Agenda Language: Approve Modification No. 1 to Contract No. 4400001633, Kiewit Building Group, for Executive Office Building (EOB) HVAC Upgrades.

TRAVIS COUNTY CONSTRUCTION CHANGE ORDER

Executive Office Building HVAC Upgrades
IFB No. B1306-028-JT
Contract No. 4400001633

TITLE: Change Proposals 1 & 2
PROJECT: Travis County EOB HVAC Upgrades
TO: Travis County Facilities Management

M5.11

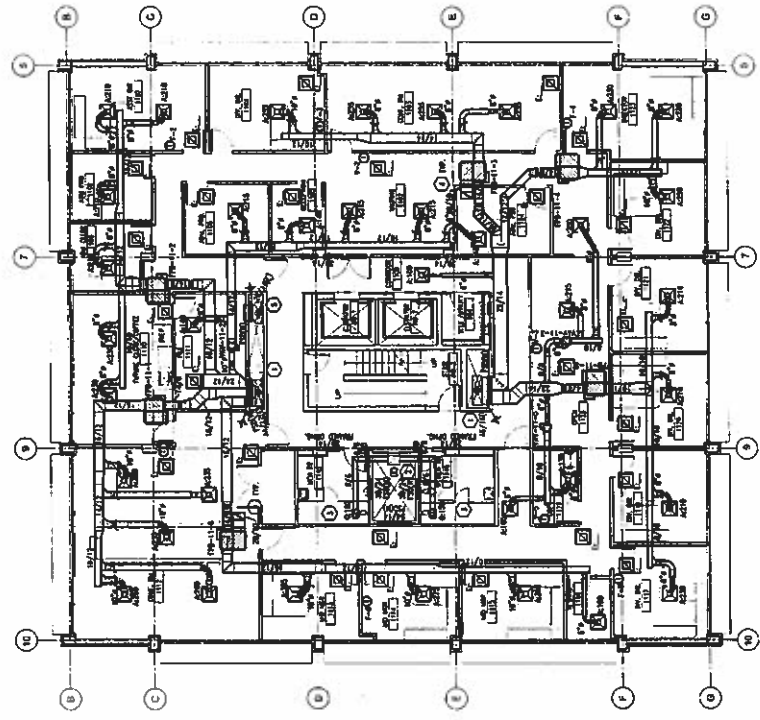
1. MODIFICATIONS TO DUCTWORK AT EACH FLOOR LEVEL.
2. MINOR ADDITIONS TO WORK AT FIRE PUMP ROOM. NOTE: SEE E5.1 FOR CHANGES ASSOCIATED WITH THIS WORK.
3. MODIFY SCHEDULE TO BEGIN FLOORS 7-11 IN FIRST PHASE OF THE WORK.
4. DEDUCT WAINSCOT DETAIL 1/A3.0 FROM KW PORTION OF THE WORK.

PROJECT NO.	154877
CONTRACT NO.	154877
SCALE	As Shown
DATE	10/15/2014
CONTRACTOR	TIG
SHEET TITLE	PLUMBING 5TH-11TH FLOOR PLAN
SHEET NUMBER	P5.5

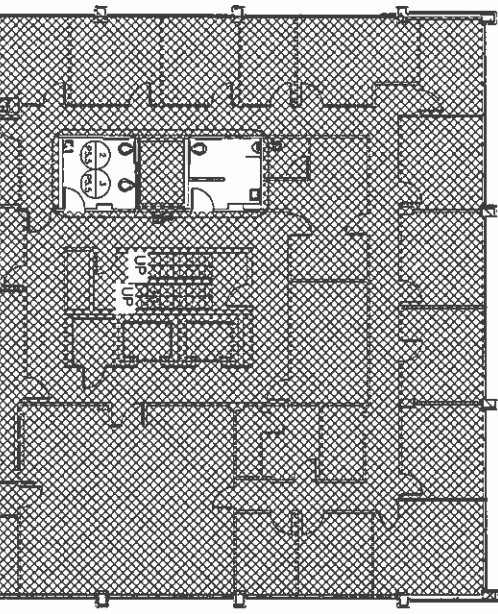
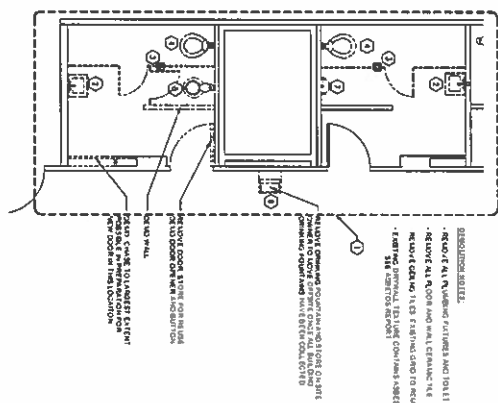
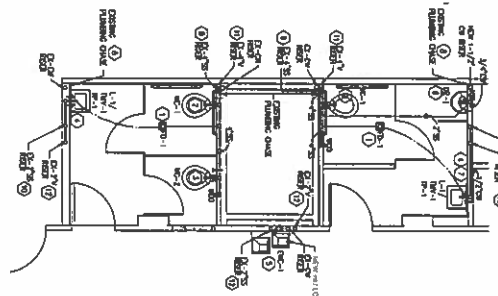
1. MODIFICATIONS TO RESTROOMS
